D. General/Miscellaneous

G-9

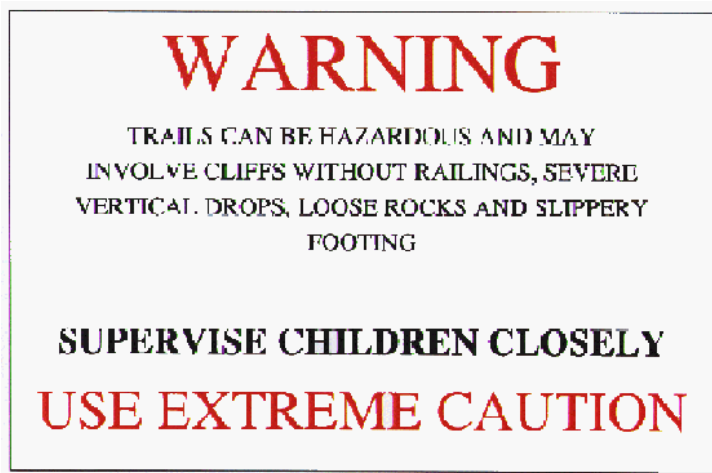
Safety signage may be
required on trails or roads, and
not just those areas directly on
the water.

Text is fine for initial layout, but
final sign should have
proportional borders.

G-10

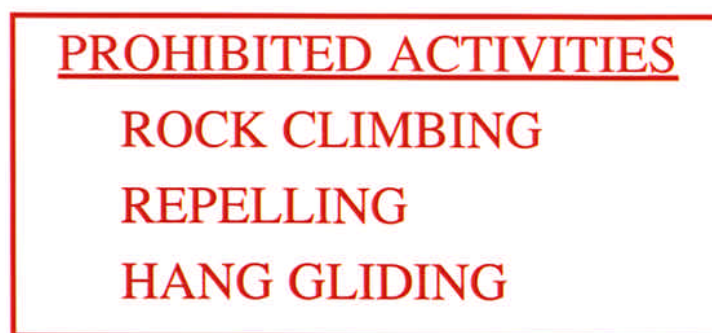
Specialized trail and access markings have added effectiveness. Specific mention of children acts as an extra warning.

Text is fine for initial layout, but final sign should have proportional borders.

G-17

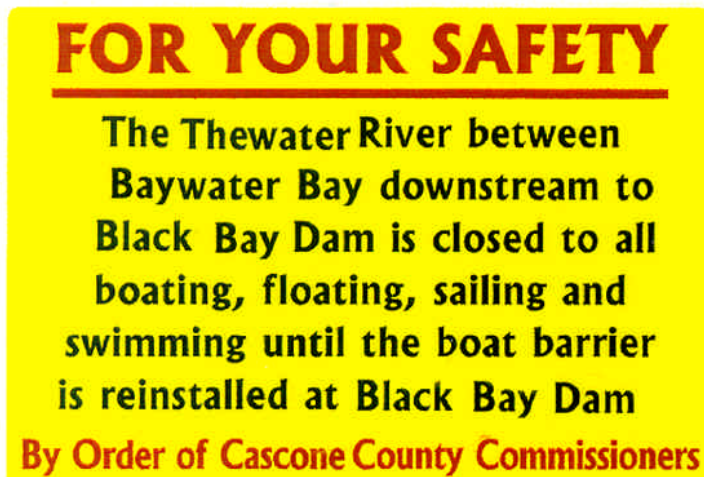
Redirecting observer to a safer area can decrease trespassing and control access.

G-21

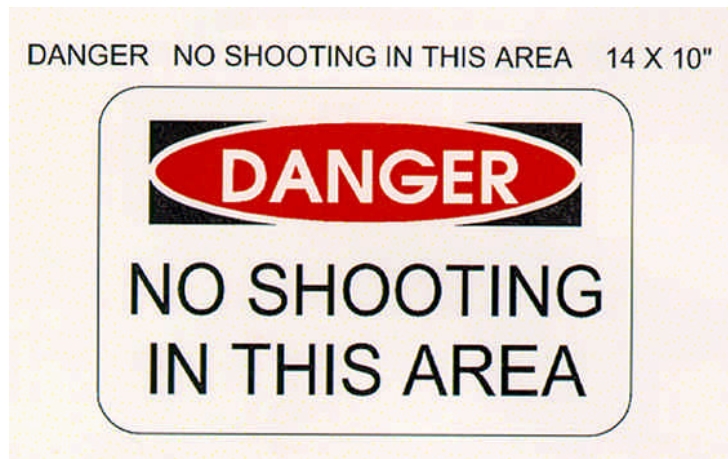
Specialized trail
signage indicates
unique trail
conditions.

G-22

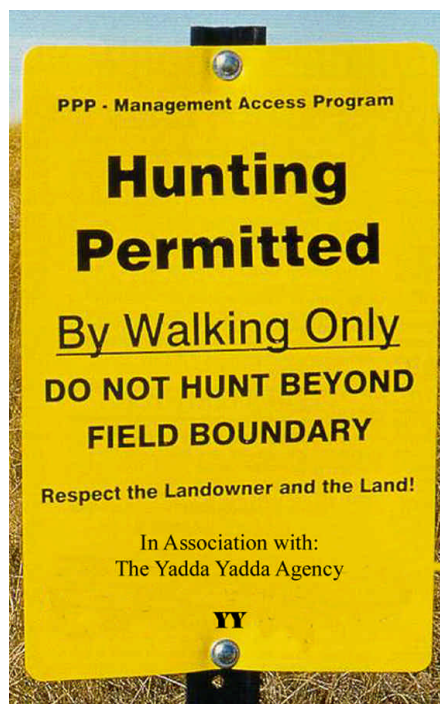
Use of standardized sign format to increase effectiveness.

G-31

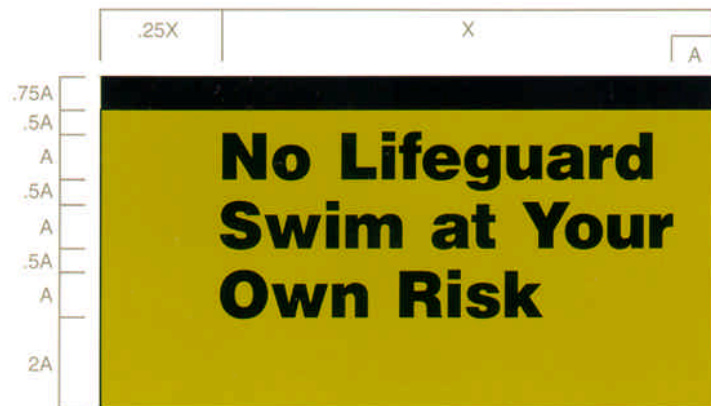
Identifies non-obvious conditions and level of risk involved with activity. Also indicates level of supervision. Proper color, proportioning, capitalization, and font increases effectiveness.

Emergency contact information (police/fire/rescue) may provide additional safety measure for viewers.

G-33

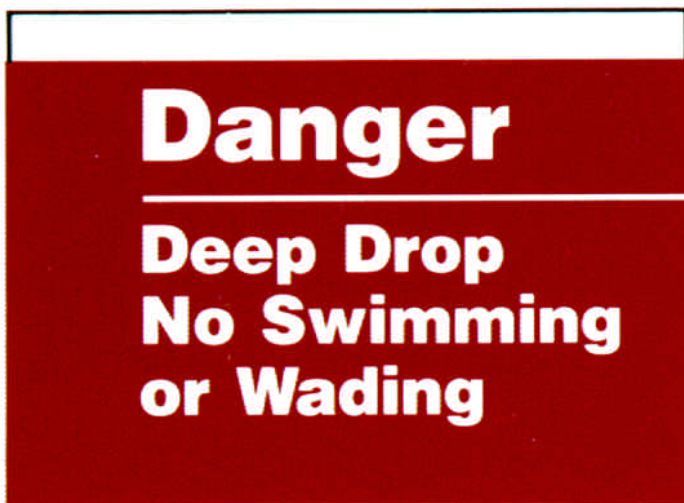
Important for areas with fluctuating water levels, or in areas with high turbidity. May also increase safety in areas with clear water where water is more shallow than viewer perceives. Proper color, proportioning, capitalization, and font increases effectiveness.

G-34

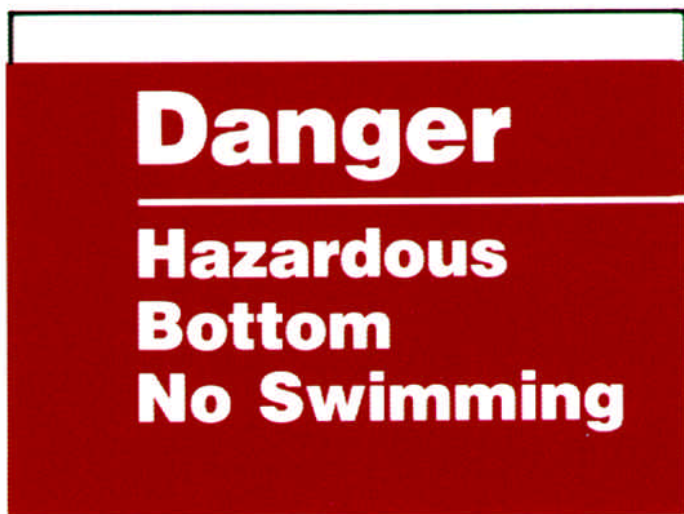
Identifies non-obvious hazard. Important for areas with fluctuating water levels, or in areas with high turbidity. May also increase safety in areas with clear water where water is more shallow than viewer perceives.

G-38

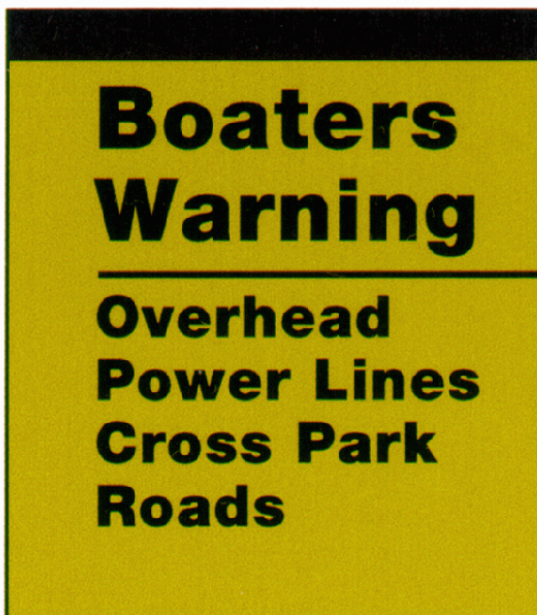
Hypothermia and decreased physical ability associated with exposure to cold water may represent a potential hazard to swimmers or anglers. Identifies that conditions may occur at any time, heightening awareness for all seasons.

G-40

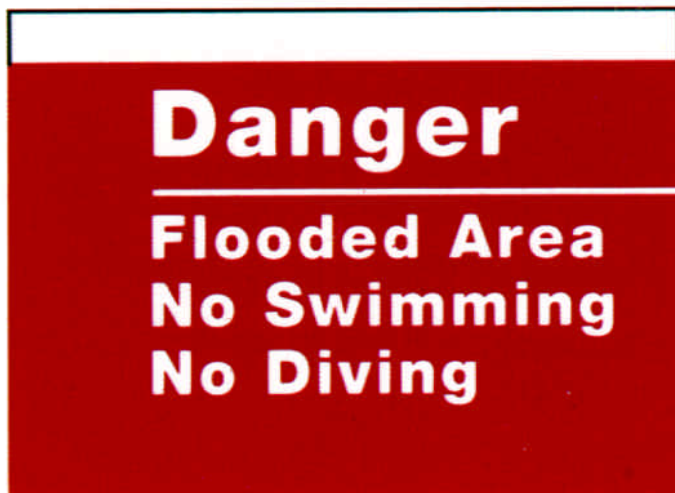
Important for areas with fluctuating water levels, or in areas with high turbidity. May also increase safety in areas with clear water where water is more shallow than viewer perceives. Proper color, proportioning, capitalization, and font increases effectiveness.

Assess need for sign at bridges, docks, cliffs, or other high area with access to the water.

G-43

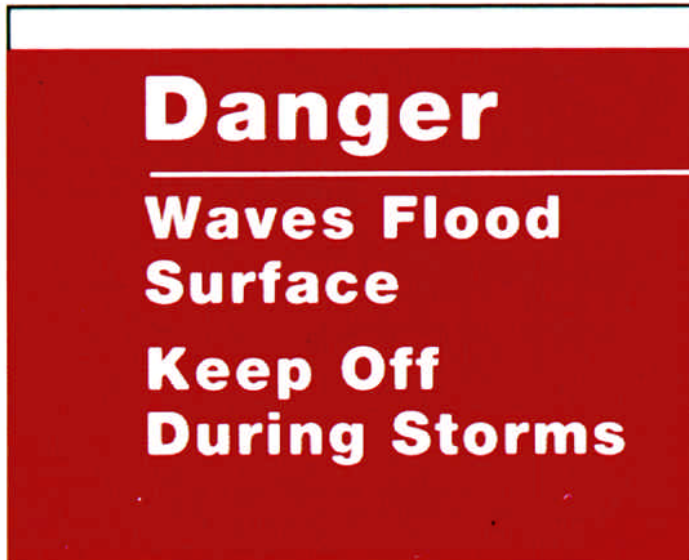
Identifies temporary condition that may restrict activities normally permitted. Trigger word indicates level of risk associated with conditions. More effective when put in place and removed as conditions change.

G-45

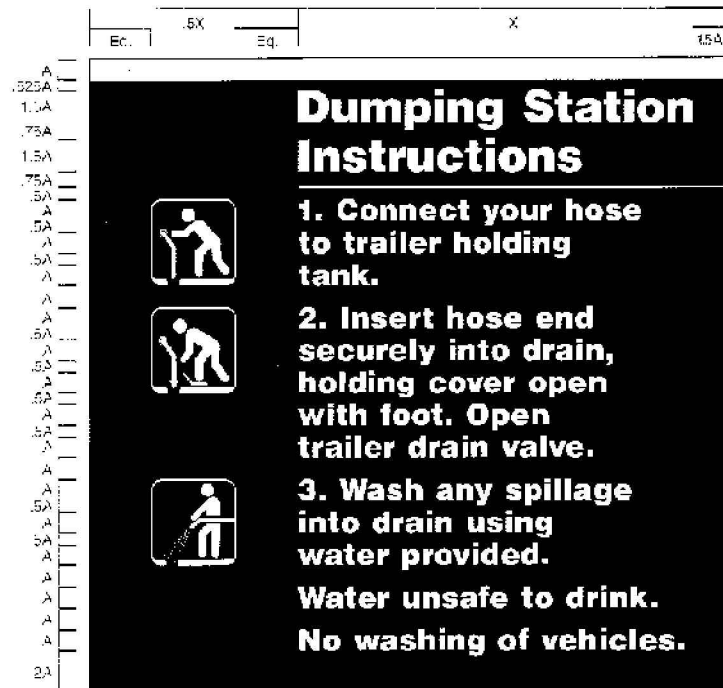
Good use of parallel posting
of bilingual signage. Use of
identical format, direct
translation, and prohibitive
symbol increases viewer
recognition and increases
effectiveness.

Another sign should direct
viewer to potable water
supply.

G-47

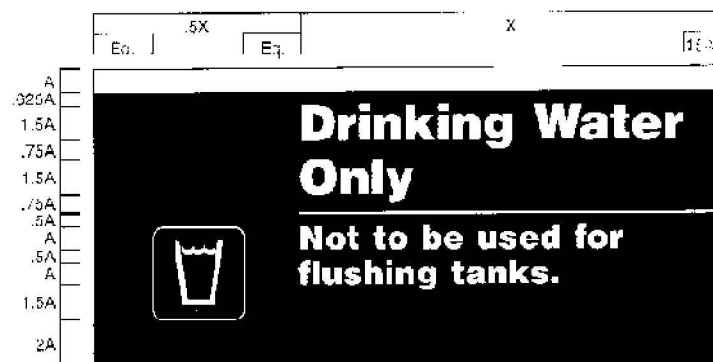
USACE sign design for
dumping stations. Gives
step by step instructions
that prevent users from
creating unsanitary or
dangerous conditions.
Use of well designed
symbols immediately
next to direction text
increases effectiveness.

G-48

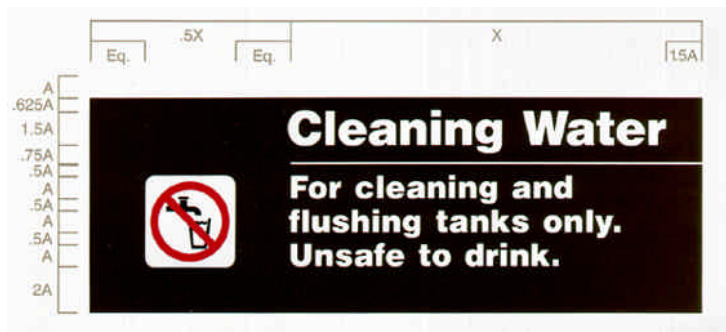
Identifies accepted and
prohibited uses for water.
May reduce the possibility of
a user causing a health risk.
Use of symbol increases
glance legibility. Notes on left
and top of sign show
proportion/scaling design
information according to
USACE guidelines (see
appendix A).

Include site on maintenance
schedule if necessary to
prevent health risk.

G-49

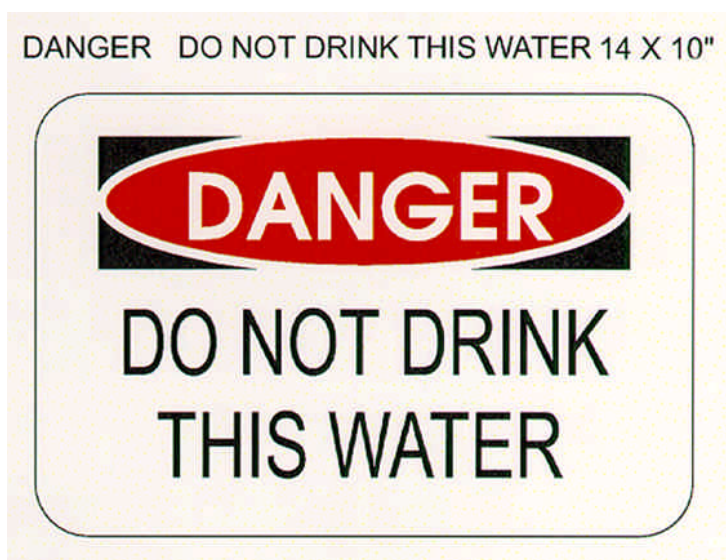
Identifies use for water
source and reduces
chance of unintentional
exposure to health risk.
Notes on left and top of
sign show
proportion/scaling design
information according to
USACE guidelines (see
appendix A).

Another sign should direct
viewer to potable water
supply.
